OIL - OIL TANK ASSEMBLY - PROVIDE AN OIL TANK OVERFILL WARNING PLATE - CATEGORY CODE 4
- MOD.ENG-79-0023

V2500-ENG-79-0023

SERVICE BULLETIN

Oil Tank Overfill Warning Plate Fig.1

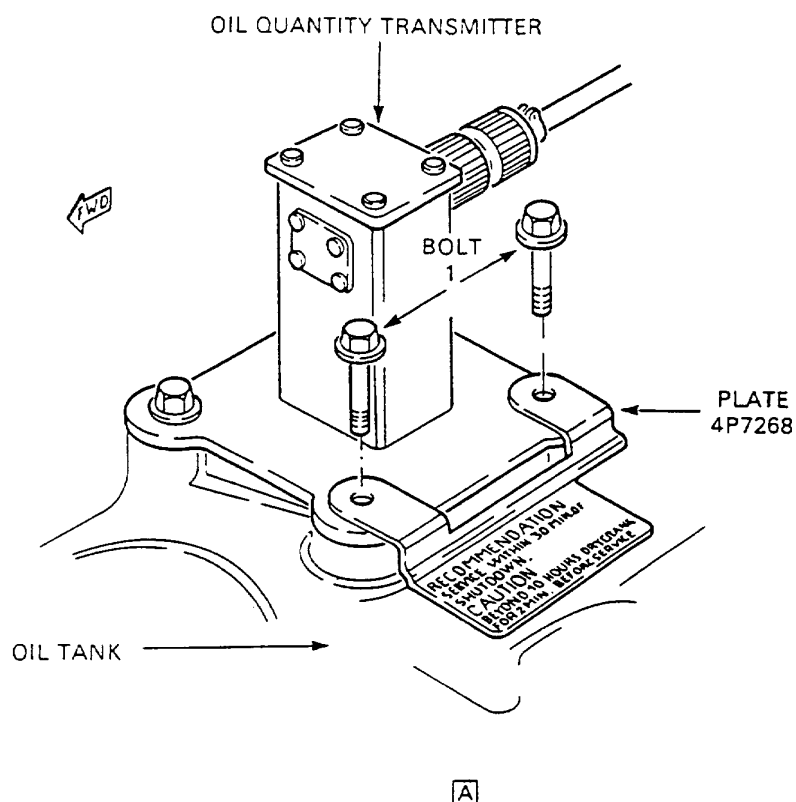
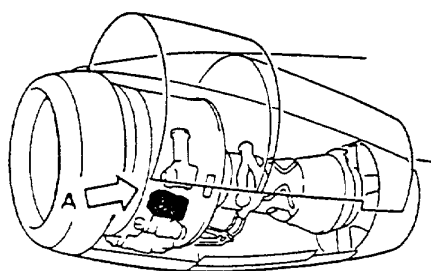
In order to highlight the importance of a correct oil refilling a warning plate has been added on the oil tank. Refer to Fig.1.

- (2) Loosen the four bolts that attach the flange of the oil quantity transmitter to the oil tank. See Fig.1.
- (3) Remove the two front bolts (1).

- (1) Install the 4P7268 plate on the flange of the oil quantity transmitter. See Fig.1.
- (2) Install the two front bolts (1)
- (3) TORQUE the four bolts to 100 lbf_n (1,13 mdaN) (Ref TASK 70-23-11-911-010).
- (4) Close the fan cowl panels, refer to Aircraft Maintenance Manual, 71-13-00.
